NEW JERSEY TRANSIT CORPORATION

BAY HEAD YARD SUBSTATION REPLACEMENT INVITATION FOR BID NO. 17-026X

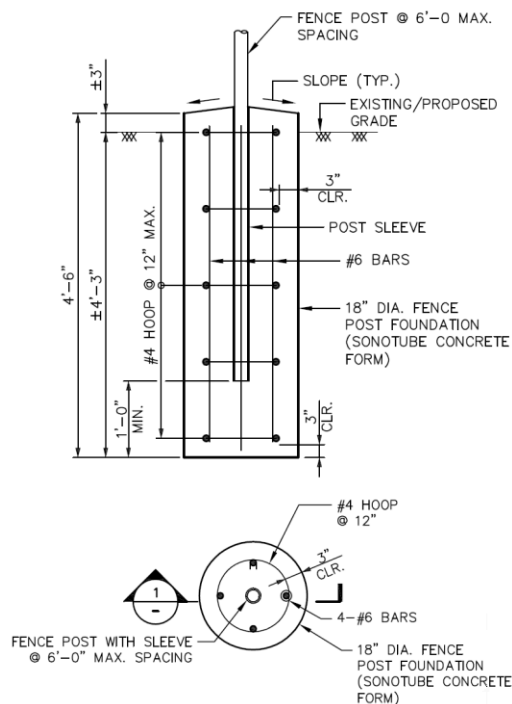
- 28. Please clarify the height of the Chain Link Fencing; Spec Section 02821, 2.02.A indicates an 8' High Fence while Dwg. C-500 indicates a 10' High Fence.**

10' high fence to be used.
